SS PETRAKIS NOMIKOS

REINFORCEMENT REQUIRED ON ACCOUNT OF REMOVAL
OF 2ND AND 3RD DECK

Reinforcement required on
account of removal of
second & third decks.

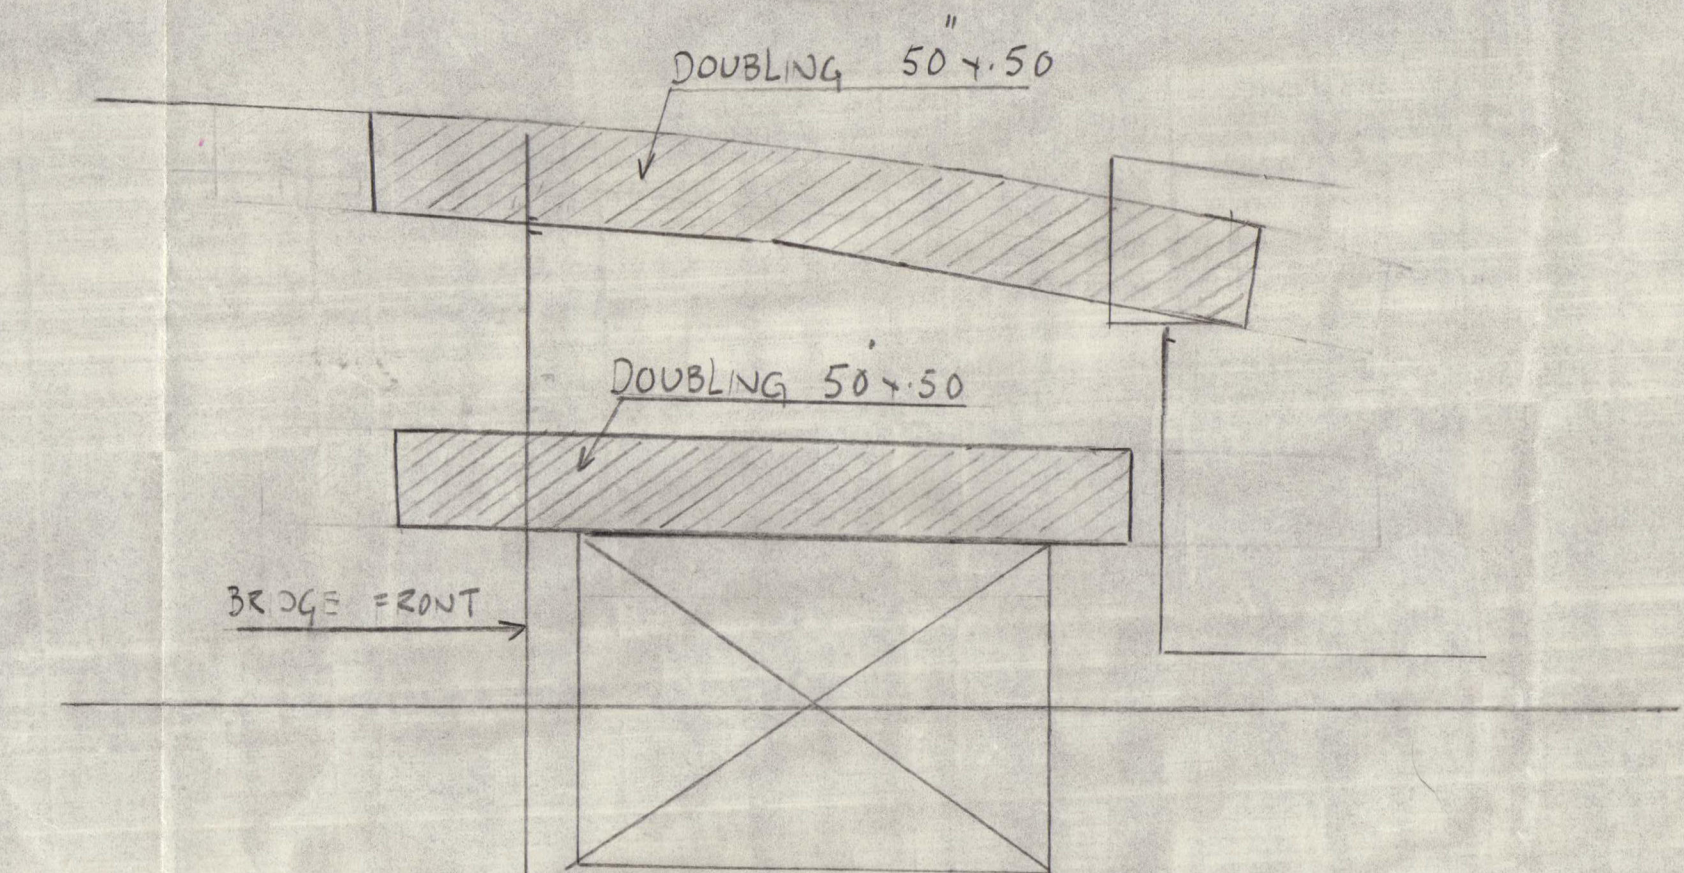
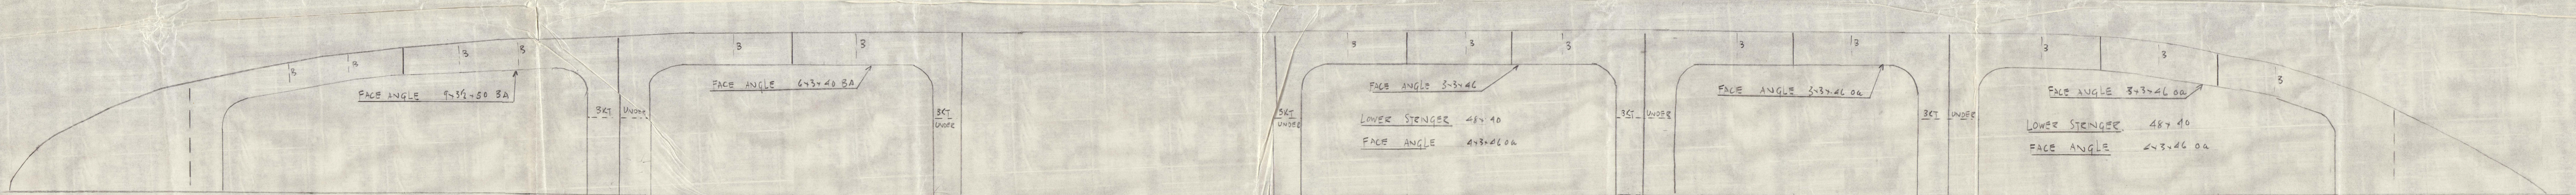
HA 1150
arrange to provide about
10' clearance
above a 10' high
structure at rear end of
hull structure and

PILLARS TO BE FITTED TO
U D^K IN ACCORDANCE
WITH RULES

ALL WEBS 18" x 46
WITH FACE ANGLES AS SHOWN ON PROFILE
WEBS TO BE CONTINUOUS

LARGE BKTS FITTED TO STRINGER WHERE MARKED 'B'
